**The National Construction Code Volume One
Schematic Design Report for SSDA Submission**

**The Children's Hospital at Westmead
Redevelopment
Multi Storey Car Park**

**Health
Infrastructure**

Revision 2

Figure No. 2 – Northern and Eastern façades of the Multi Storey Car Park required to have openings on each storey with a minimum of 50% of the wall area

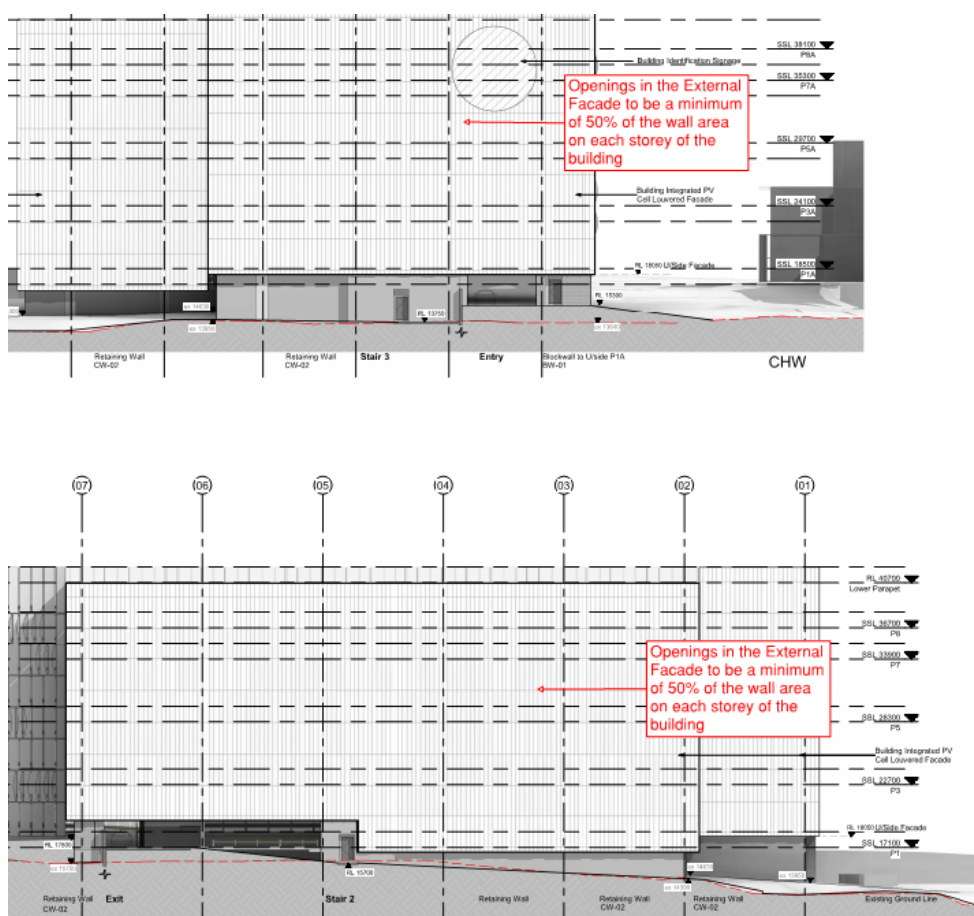
To comply with the definition of an open deck carpark, the following criteria must be achieved:

All parts of the parking storeys are to be cross ventilated by permanent unobstructed openings in not fewer than 2 opposite or approximately opposite sides; and

- a) Each side that provides ventilation is not less than 1/6 of the areas of any other side; and
- b) The openings are not less than $\frac{1}{2}$ of the wall area of the side concerned

Based on the Schematic Design Architectural Drawings submitted, the proposed façade is capable of complying with the open deck car park provisions.

Diagram No. 3 – Required separation of internal main switch room

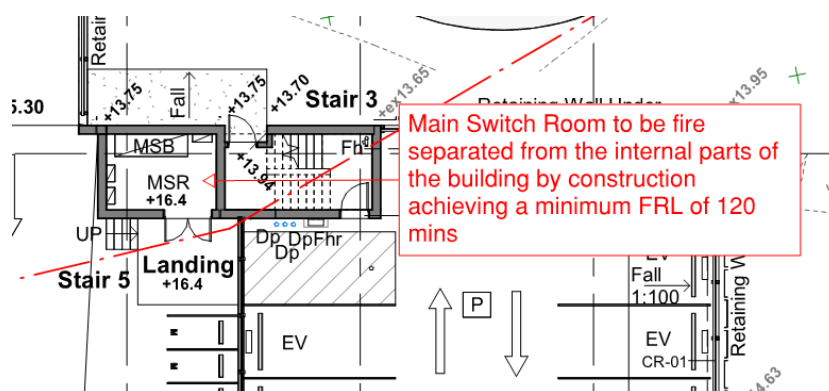
The Main Switch Room located on Level P1 is required to be fire separated from the internal parts of the building by construction achieving a minimum FRL of 120/120/120 (load bearing) or -/120/120 (non-loadbearing).

Figure No. 4 – Required exit doors from Level P1

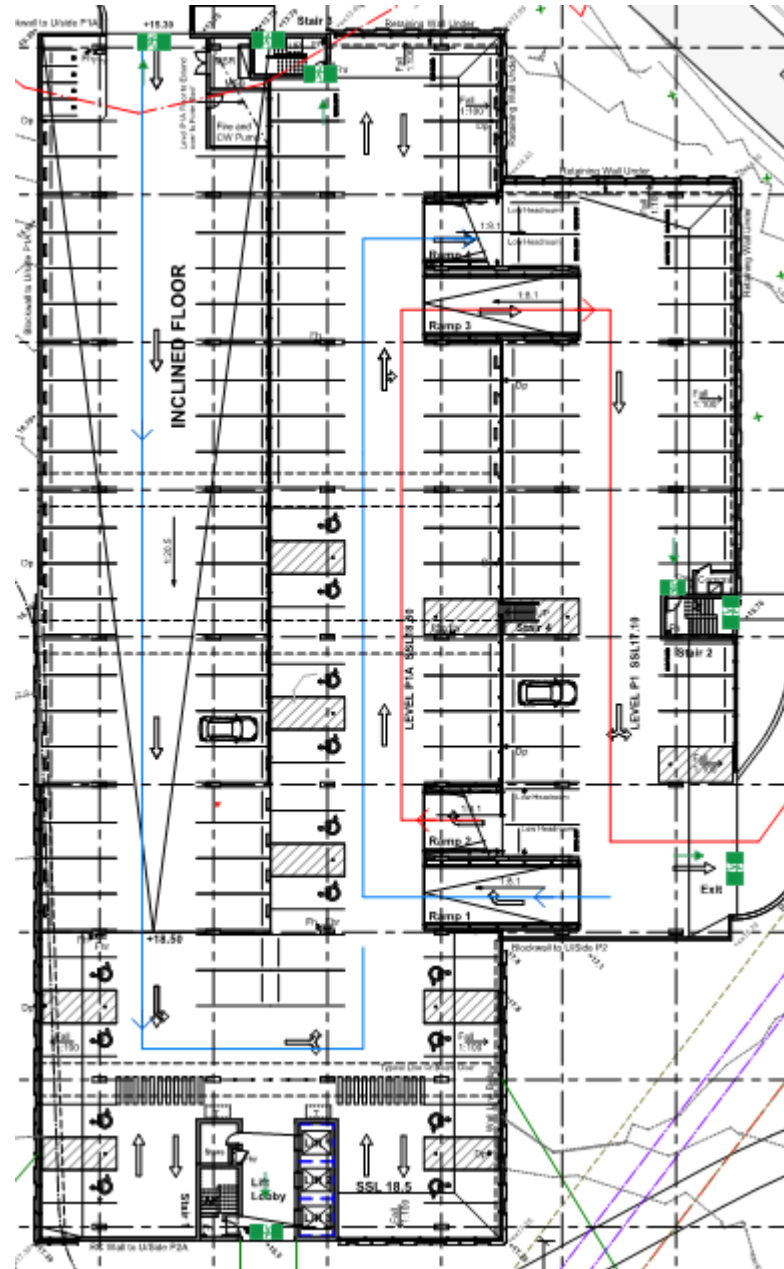
Based on the Schematic Design Architectural Drawings assessed to date, we have undertaken an egress assessment in terms of egress travel distance to an exit and based on our review, we provide the following comments:

The extended travel distance to an alternative exit will be required to be assessed as part of the Fire Engineering Performance Solution to be prepared by the appointed Fire Safety Engineer in order to demonstrate compliance with the nominated Performance Requirements of the BCA.

Figure No. 6 – Path of travel leading to exits to have a clear unobstructed width of 1000mm

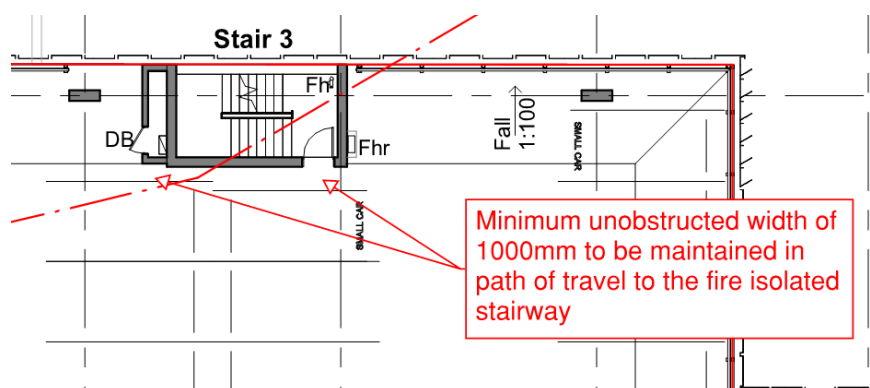
In addition, the unobstructed width of any new exit or a path of travel to an exit must not be less than 1 metre. In this instance specific attention is required to the paths of travel that lead to the fire isolated stairways where it adjoins a car parking space. In this instance, there must be a minimum clear unobstructed width of 1000mm that is provided to the path of travel between car parking spaces and adjoining walls and any built structures such as columns or services such as fire hose reels etc.

Refer to the Figure below for a typical location where a clear unobstructed width of 1000mm is required to be maintained between car parking spaces and a fire isolated stairway.

Figure No. 7 – Discharge from Fire Stair 3

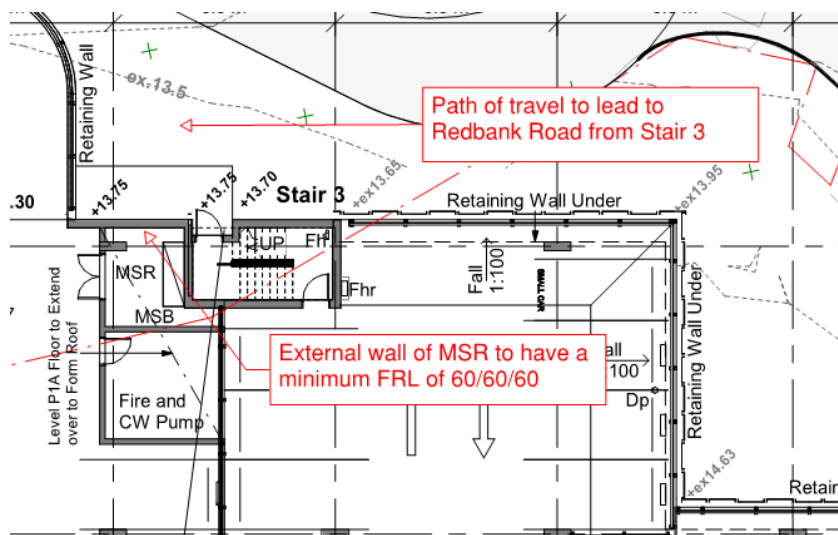
Upon discharge from Fire Stair 3, occupants are immediately exposed to the external wall of the Main Switch Room. In this instance the external wall of the Main Switch Room is required to have a minimum FRL of 60/60/60 (achieved in both directions).

Once occupants discharge from Fire Stair 3, verification is required that a path of travel (trafficable) leads direct to Redbank Road without having to pass within 6m (measured perpendicular to the path of travel) of the vehicular entry to the car park.

Figure No. 8 – Discharge from Fire Stair 1 into a covered area adjoining open space

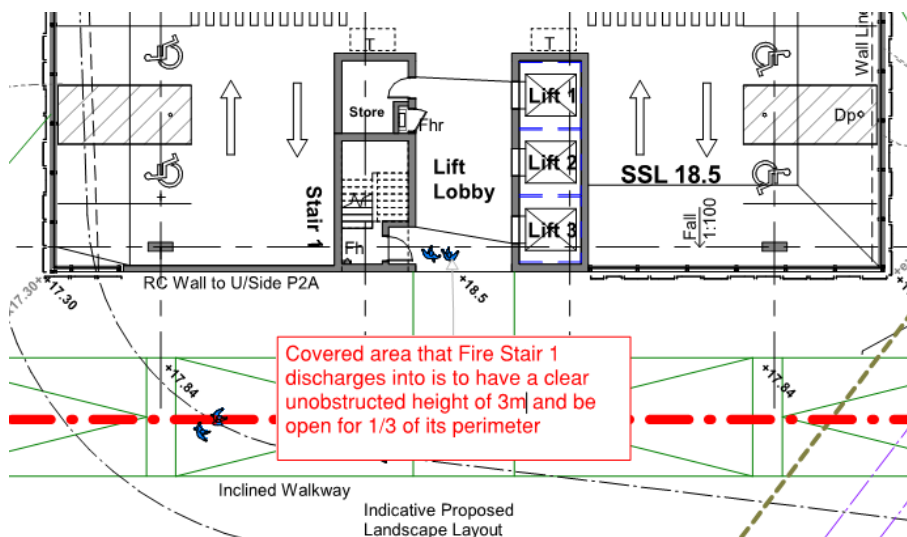
It is noted that Fire Stair 1 discharges into a covered area within the Lift Lobby on Level P1 which adjoins open space.

A fire isolated stairway is permitted to discharge into a covered area that adjoins a road or open space on the basis that the area is open for at least 1/3 of its perimeter and has an unobstructed height throughout including perimeter openings of not less than 3m and provides an unimpeded path of travel from the point of discharge to open space of not more than 6m.

If compliance cannot be achieved with the minimum clear height of the covered area including the perimeter openings, it is recommended that the discharge door be reconfigured to discharge directly to open space from Stair 1.

Figure No. 9– Vehicular ramps used as paths of travel to alternative exits to have a maximum gradient of 1:8

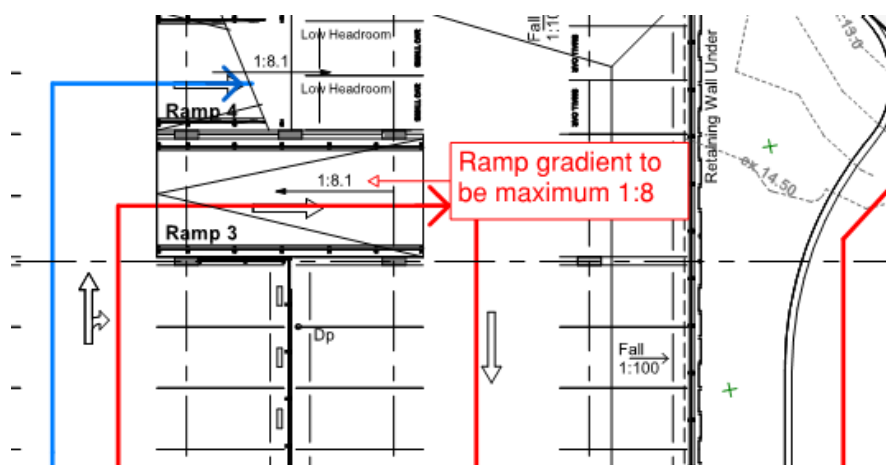
In order for egress travel distance to comply and for occupants to have the choice of alternative exits from the car parking storeys, the vehicular ramps between car park levels must have a gradient not exceeding 1:8.

Figure No. 25 – Internal on floor fire hydrants to have unimpeded access can cannot be block by parked moto vehicles

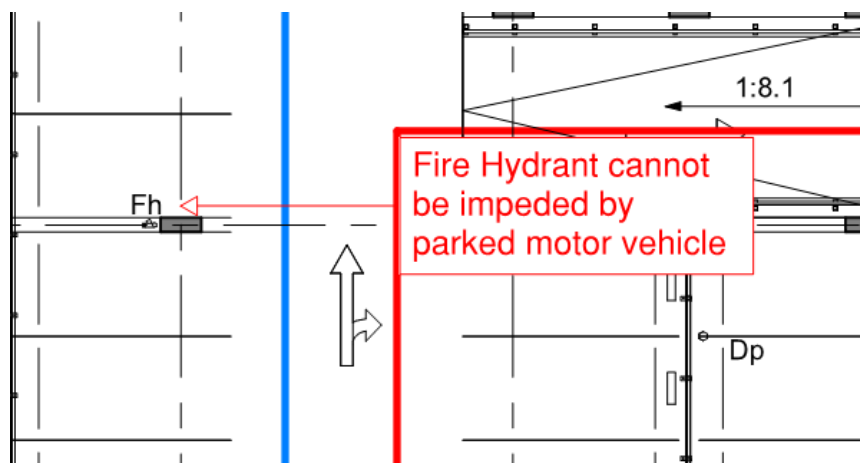
Having regard to the size of each storey, additional fire hydrants will be required to be located within the confines of each storey in order to achieve compliant coverage to each storey.

In this instance careful design consideration needs to be given to ensure that there is a clear space of 1000mm in front of fire hydrant to permit access by FRNSW. Where fire hydrants adjoin car parking spaces, bollards may need to be installed to ensure that access to fire hydrants are not blocked by motor vehicles.

Figure No. 26 – Internal fire hydrant pump room located on Level P1

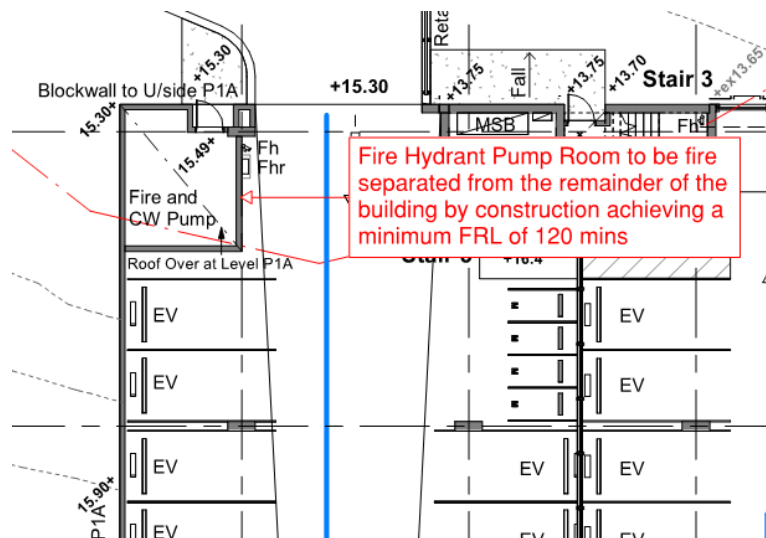
The current Architectural Design indicates compliance in this instance.

Furthermore, and due to the fact that the building is not required to be provided with an Automatic Fire Suppression System, the internal fire hydrant pump room is required to be separated from the remainder of the building by construction achieving a minimum FRL of 120 mins.

Figure No. 28 – Indicative exit sign locations on a typical car park storey

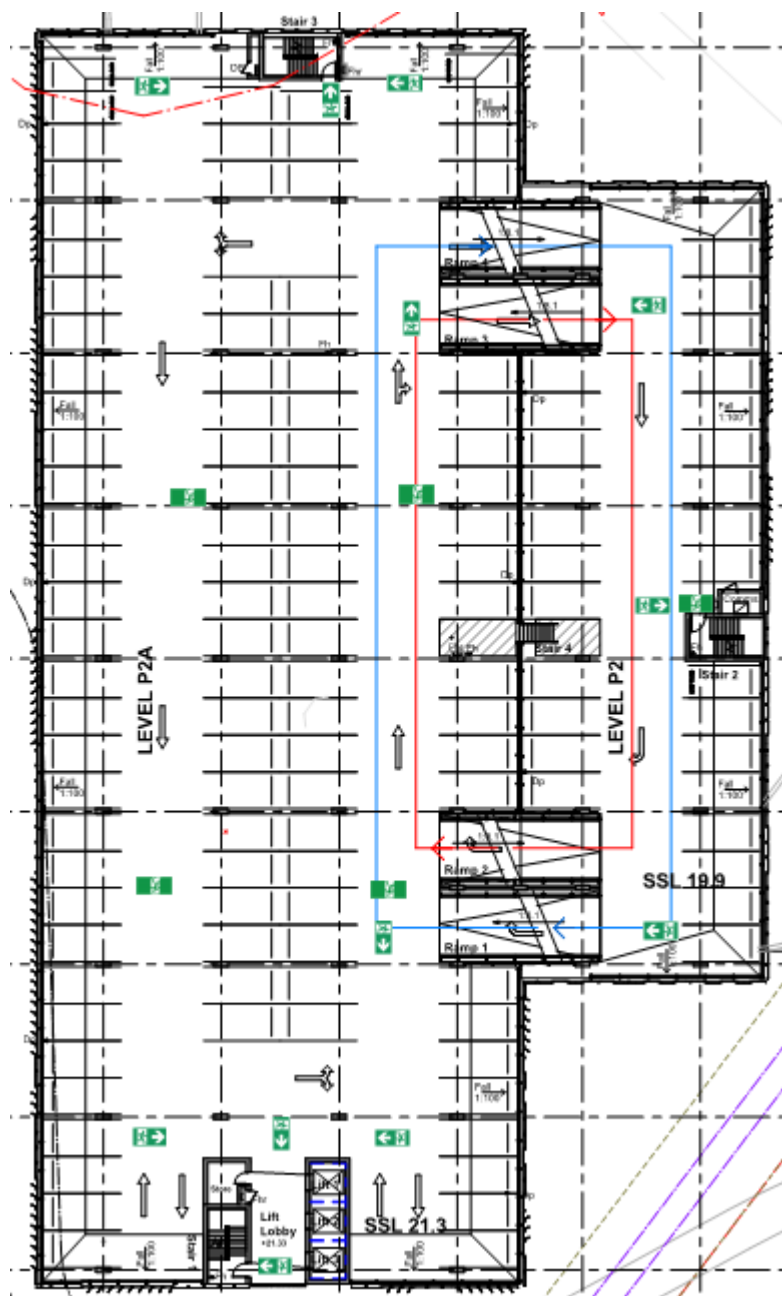
- + Doors providing direct egress from a storey to the fire isolated stairways;
- + Doors providing access from the fire isolated stairways to open space;
- + Within the lift lobby directing occupants to open space;
- + Above the vehicular entry point which is to be used for occupant egress; and
- + Throughout the car parking storeys directing occupants to the alternative exits.

The following figure details indicative exit sign locations from the typical car park storey.
